Beaver Valley Power Station - Units 1 & 2

Annual Radioactive Effluent Release Report

Unit 1 and 2 Offsite Dose Calculation Manual Changes

ODCM: Index, Matrix and History of ODCM Changes

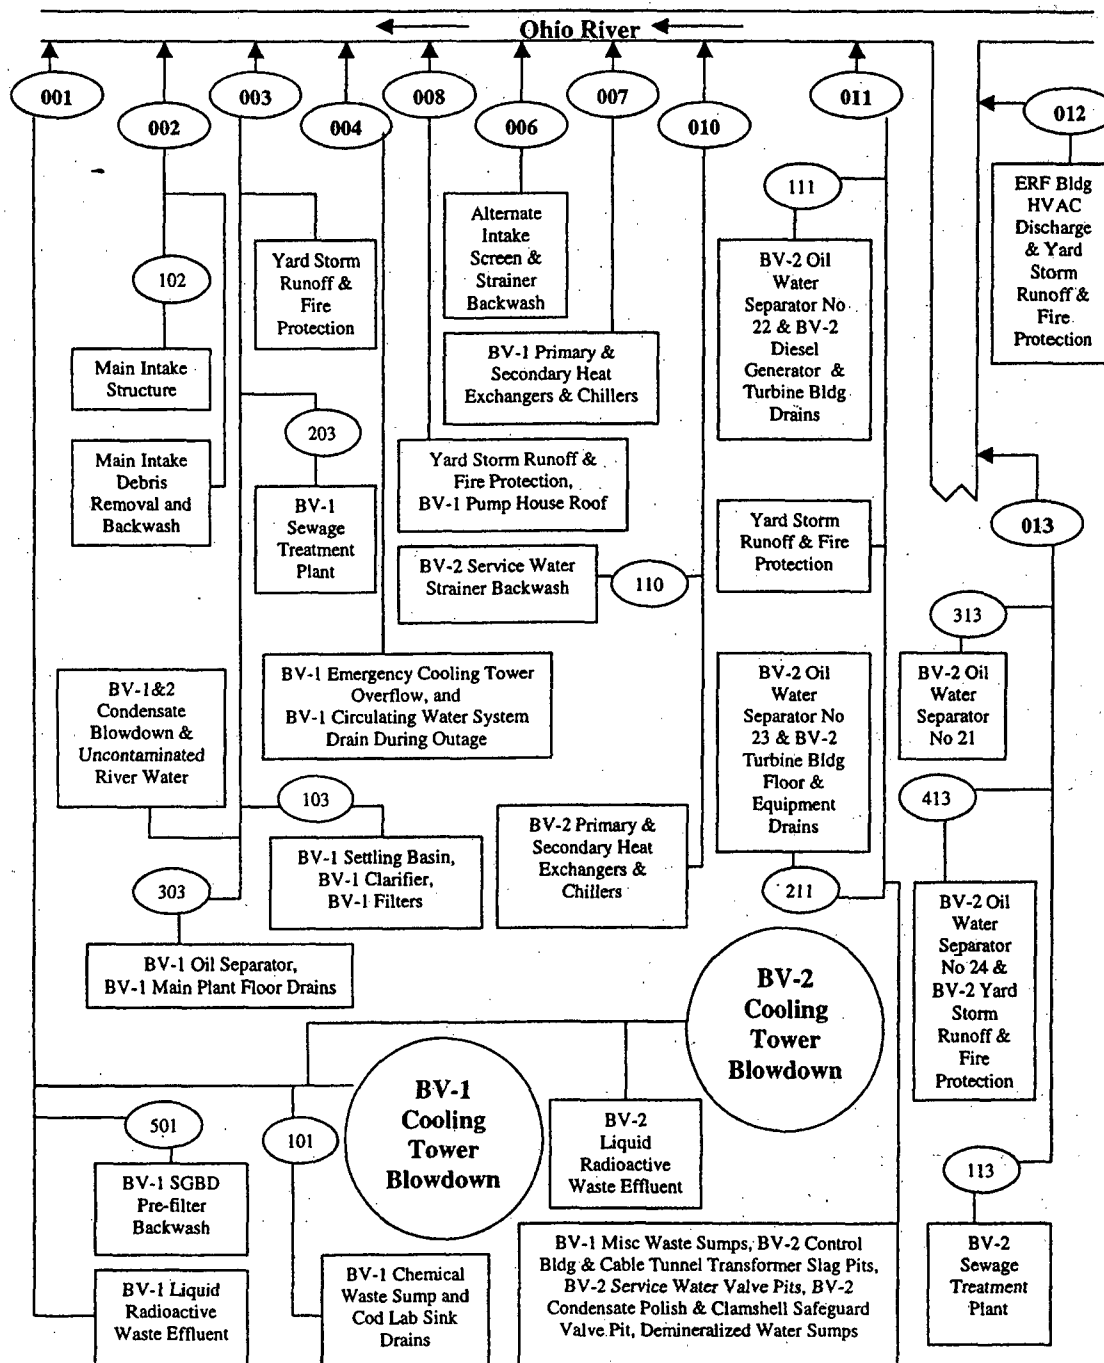
3.2.2.29	CR 05-03306, Incorporated Improved Technical Specifications (ITS).		
3.2.2.30	CR05-03854, ODCM Figure for Liquid Effluent Release Points Needs Updated. CA-01, revise ODCM procedure 1/2-ODC-2.01 (ODCM: Liquid Effluents) Attachment D, Figure 1.4-3 to incorporate a modified version of Plant Drawing No. 8700-RM-27F.

CR 05-03854, ODCM Figure for Liquid Effluent Release Points Need Updated. CA-01, revise ODCM procedure 1/2-ODC-2.01 (ODCM: Liquid Effluents) Attachment D, Figure 1.4-3 to incorporate a modified version of Plant Drawing No. 8700-RM-27F.
